# UNITED STATES PATENT AND TRADEMARK OFFICE

10/689,465

**Office Action Summary**

*Ex's  
Attachment  
8/20/04*

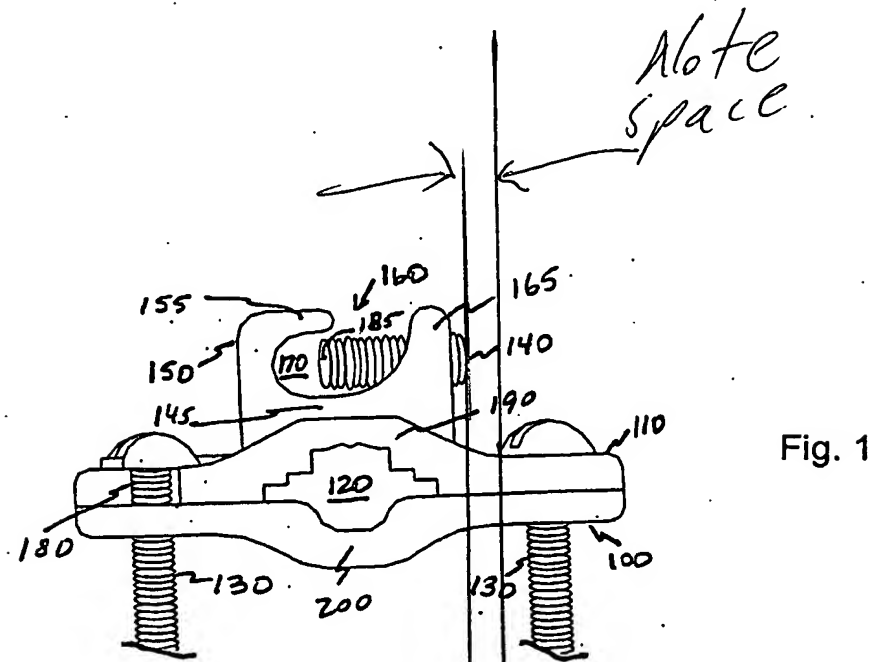
Claims 9 and 11-17 are rejected under 35 U.S.C. 112, first paragraph, as failing to comply with the written description requirement. The claim(s) contains subject matter which was not described in the specification in such a way as to reasonably convey to one skilled in the relevant art that the inventor(s), at the time the application was filed, had possession of the claimed invention. Regarding claim 9, the apparatus as claimed including that the set screws extends to prevent the removal of one of the screws was not described in the specification in such a way as to reasonably convey to one skilled in the relevant art that the inventor(s), at the time the application was filed, had possession of the claimed invention. Nothing is mentioned in the specification

regarding this feature. In fact the figures show quite the opposite (see attachment), in particular that the set screw is shown as being spaced from the path of the screw 130. The limitation is given little weight and must be removed.

Applicant is required to cancel the new matter in the reply to this Office Action.
